**RE: Lot 25 Block 6 Unit 18 SAD 228
6519 Pato Rd. NW
Volcano Cliffs Subdivision
Grading and Drainage Plan
Engineers Stamp Date 9/9/19 (D10D003M25)**

Based upon the information provided in your submittal received 10/9/19, this plan cannot be approved for Grading Permit until the following comments are addressed.

TITLE: 6519 Pato Rd. NW Grading & Drainage Plan

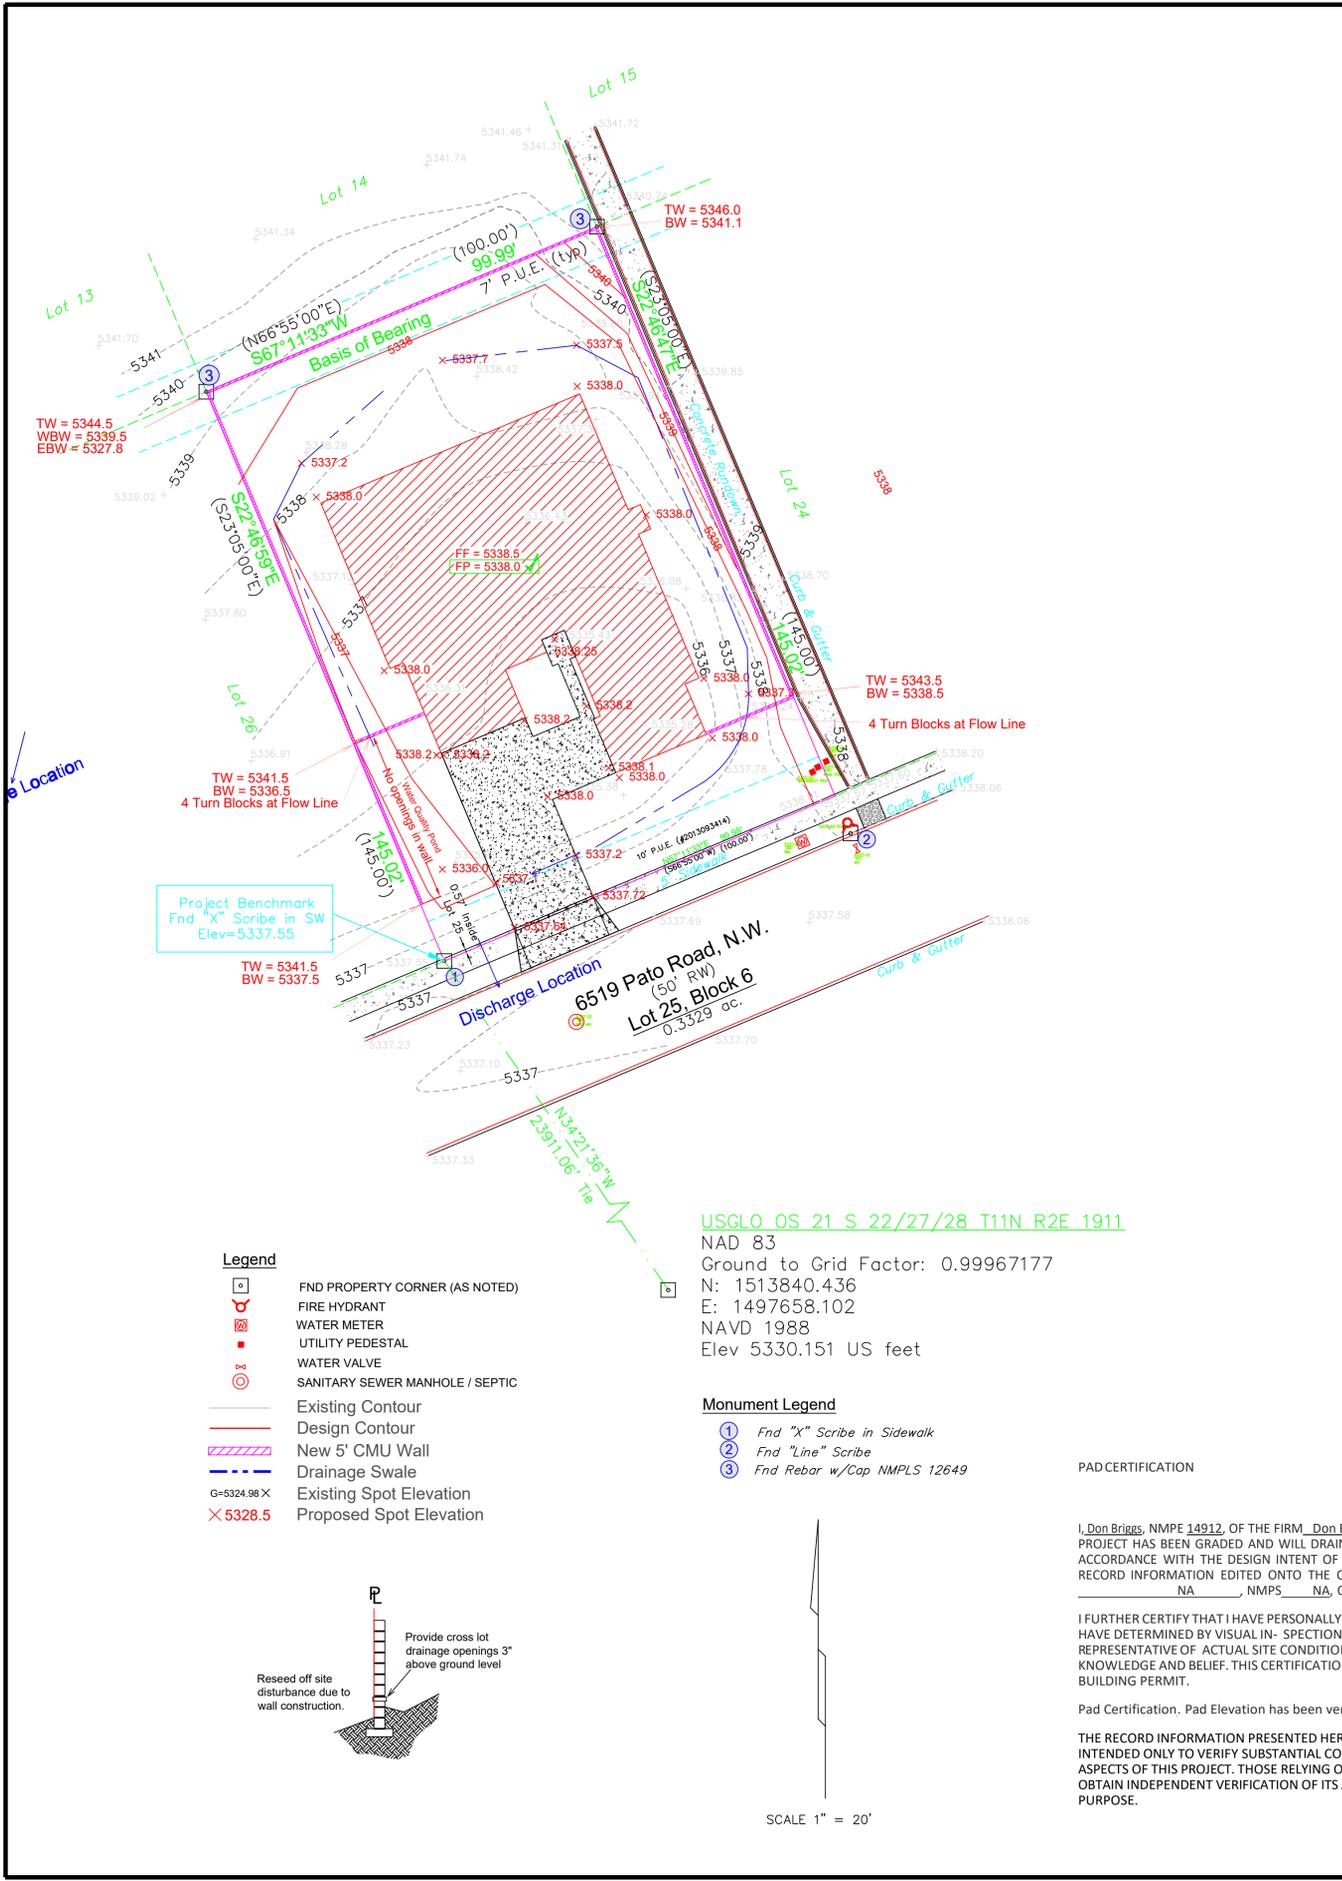
- Remove the dirt from the street and off the sidewalk. Dirt is not allowed to be used as a curb ramp, lumber or millings must be used to keep dirt, debris or sediment out of ponding areas.

Prior to building permit approval a pad certification must be obtained.

Prior to Certificate of Occupancy release, Engineer Certification per the DPM checklist of this plan will be required.
